# COLORADO GEOLOGICAL SURVEY

**Subject: Gold Hill Mesa Filing No. 11,  
Final Plat-AR FP 19-00201; and Development Plan-AR DP 19-00198;  
City of Colorado Springs, El Paso County, CO; CGS Unique No. EP-19-0132**

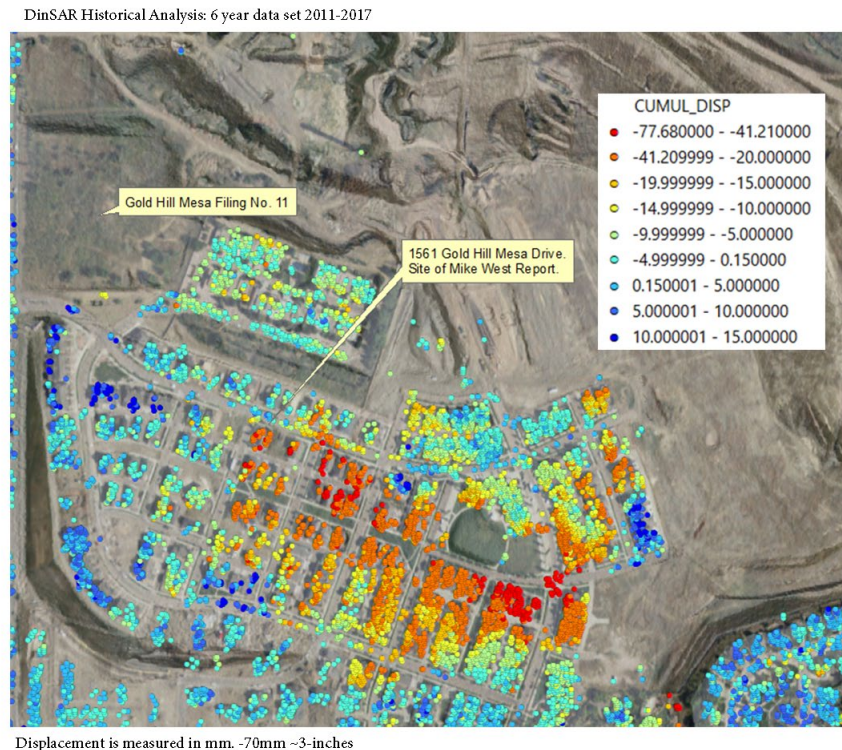
Following concerns raised by the city and local residents CGS commissioned this type of satellite study for Gold Hill Mesa. The study was performed on a stack of 162 images covering the period from June 24<sup>th</sup>, 2011 to October 14<sup>th</sup>, 2017. This work shows 3-inches of cumulative vertical settlement around the area of concern in the Mike West reports. This area generally corresponds with some of the deep, saturated slime deposits outlined in the reports. The cumulative movement recorded in the Satellite study is shown in the following figure. (The data is collected on fixed points associated with houses, streets, etc., so no points are in the undeveloped areas. The movement is relative movement and may not be exact at specific locations.)

The geotechnical reports on file for Gold Hill Mesa do not fully characterize the slimes versus the sands, but typically treat the mill tailings as a relatively homogenous unit. The area of greatest measured settlement as depicted in the DinSAR image corresponds to deep saturated slimes beneath tailing sands. Borings historically drilled in this area tend to be shallow and not drilled to bedrock. Minimal or no sampling and testing of the slimes was done.
